VSP-30
May 20, 1981

VENDOR SERVICE PUBLICATION

Subject: Bendix Service Bulletins 599A, 609A, 610,
613, 614

SERVICE BULLETIN NO. 599A
(Supersedes Service Bulletin No. 599)
Engineering Aspects are
FAA Approved

Figure 1. Terminology

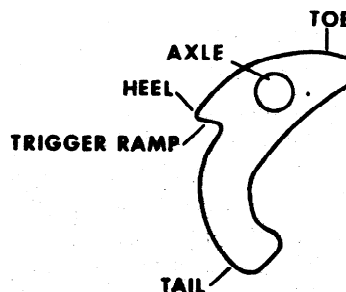
- a. Bend the end of a stiff wire into a right angle 1/8 inch long, maximum.
- b. Position impulse coupling so that heel of flyweight (see figure 1) is adjacent to stop pin. Reach

Figure 2. Checking Flyweight to Stop Pin Clearance

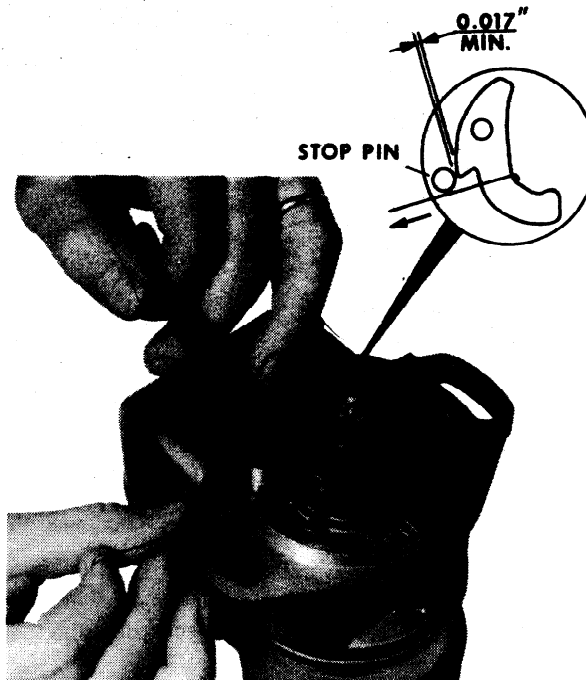
between cam and flyweight with bent wire, as near as possible to the stop pin, and pull outward on the flyweight as shown in figure 2.

c. While pulling flyweight outward, insert feeler gages to measure the clearance between the heel of the flyweight and the stop pin, assuring a minimum of 0.017 inch exists.

d. If less than 0.017 inch clearance exists, this is cause for immediate rejection of the impulse coupling cam assembly, or possibly the entire impulse coupling. Refer to the applicable Magneto Overhaul Instructions for inspection procedures to determine if other impulse coupling parts are still serviceable.

Figure 6. Flyweight Tail Condition Check

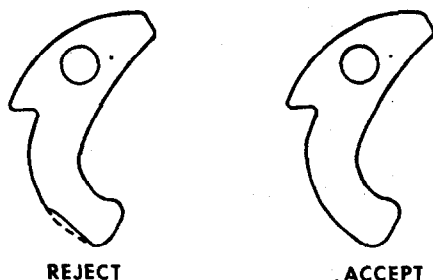
4. Flyweight tail condition must be given a visual examination to determine if flyweight is still serviceable. The surface at the apex of the beveled edge must blend smoothly with the outer contour of the flyweight. No flattening, denting or chipping is permissible. Any irregularity of this surface is cause for immediate rejection of the cam assembly. (See figure 6)

Figure 1.

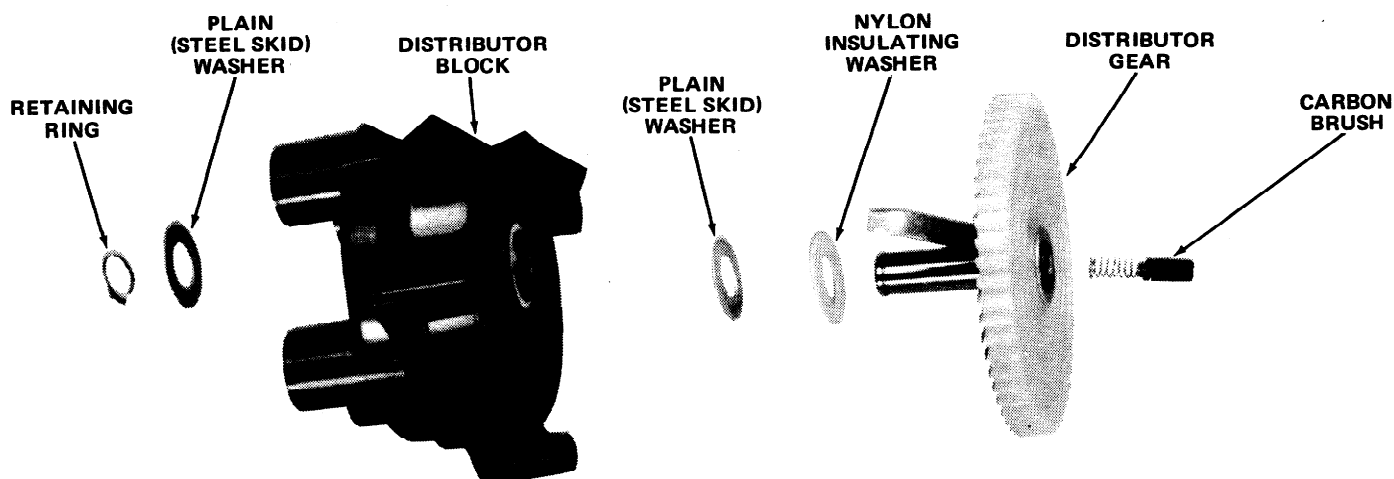
REASON FOR BULLETIN: To announce availability of an improved insulated distributor gear (kit) for the subject magnetos.

This bulletin announces availability of an improved, insulated distributor gear in kit form which is interchangeable between the D-2000/D-2200 & D-3000/D-3200 series magnetos. The kit includes all parts (except distributor block) as identified in figure 1.

Assembly sequence of the gear kit to distributor block is shown in Figure 1.

Figure 1. Location of Identification Mark

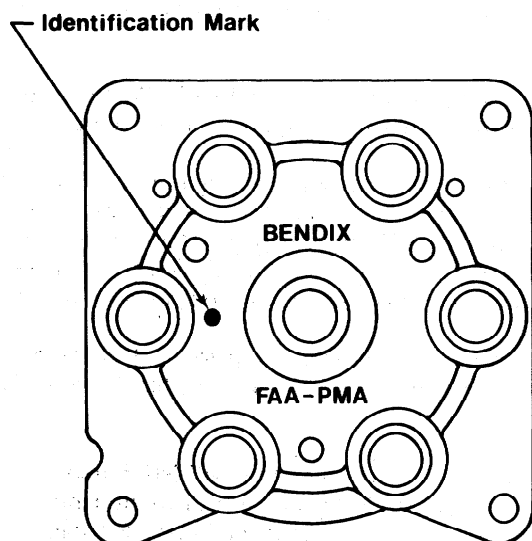
1. To announce the availability of an improved Diallyl Phthalate (DAP) green distributor block incorporating a new design "Gripper" oilite bushing.
2. To alert users of a possible loose oilite bushing in the original green DAP distributor block. Field reports indicate that the bronze oilite bushing in the current green distributor block may become loose and turn within the block. This condition could wear the block enough to cause the distributor gear to become mistimed resulting in rough engine operation.
3. To provide instructions for inspection and/or replacement of the original green distributor blocks with the new "Gripper Bushing" green distributor blocks as required.

The new "Gripper Bushing" will eliminate the possibility of the bushing becoming loose. The "Gripper Bushing" block can be identified by a circular shaped mark 0.188 inch \pm 0.031 inch in diameter raised 0.010 inch to 0.030 inch above the surface of the block. This mark is located on the tower side of the block, as indicated in figure 1.

Figure 6. Distributor Gear/Block Exploded View

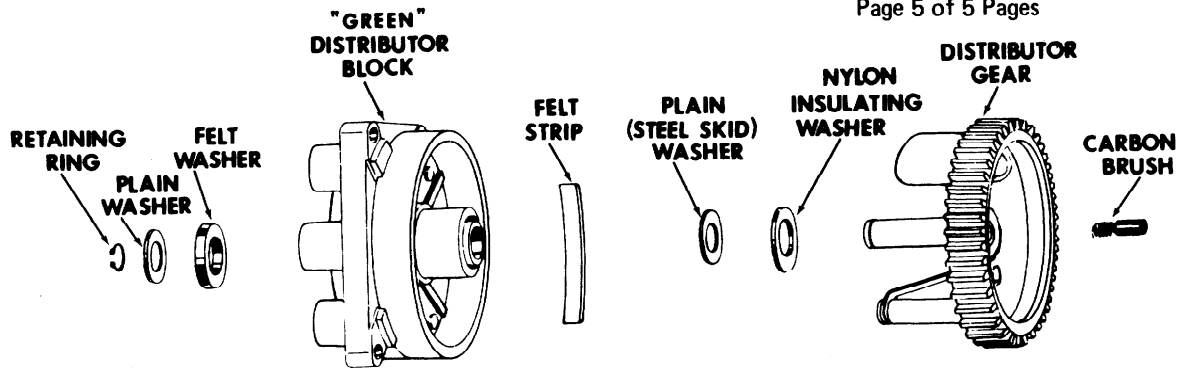
8. For reassembly, reference figure 6 and proceed as follows:

- d. Remove the "Gripper Bushing" distributor block and re-lubricate if necessary with Bendix Distributor Block Lubricant, P/N 10-391200.

- e. Install the felt washer, P/N 10-50752, in the block and re-lubricate if necessary with Bendix Distributor Block Lubricant, P/N 10-391200.

Figure 1 Defect

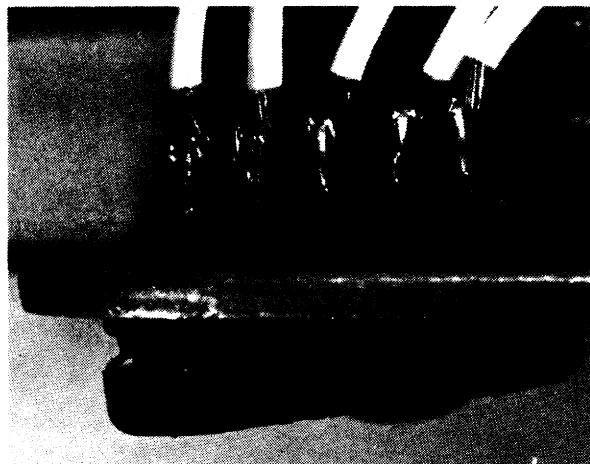
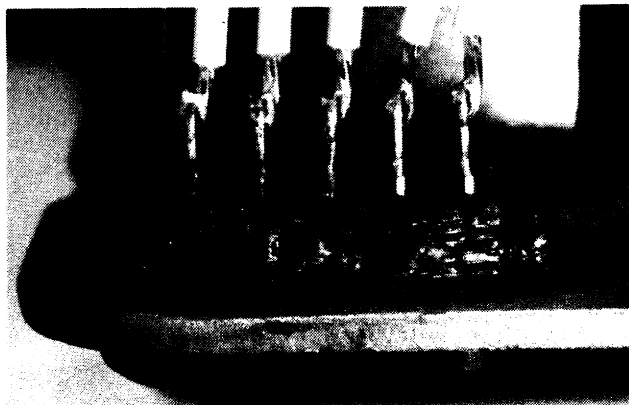
Bushing (connector), P/N 10-382943, may become loose in the vibrator plate and cause the grounding of both magnetos with possible loss of ignition. See figure 1 (defect).

5. Use RTV (Silicone rubber sealant, or equivalent, Dow Corning Corp., Midland, Mich. 48640) to seal terminal bushing to the mounting plate. Apply a small bead completely around the bottom of bushing to secure the bushing to the plate as shown in figure 2 (repaired). If RTV is not available, use either Hysol, Epoxi-Patch Kit (general purpose), Hysol Corp., Olean, NY or Conap, Easyepoxy Kit (K20 general purpose) 1405 Buffalo St., Olean, NY, or equivalent.
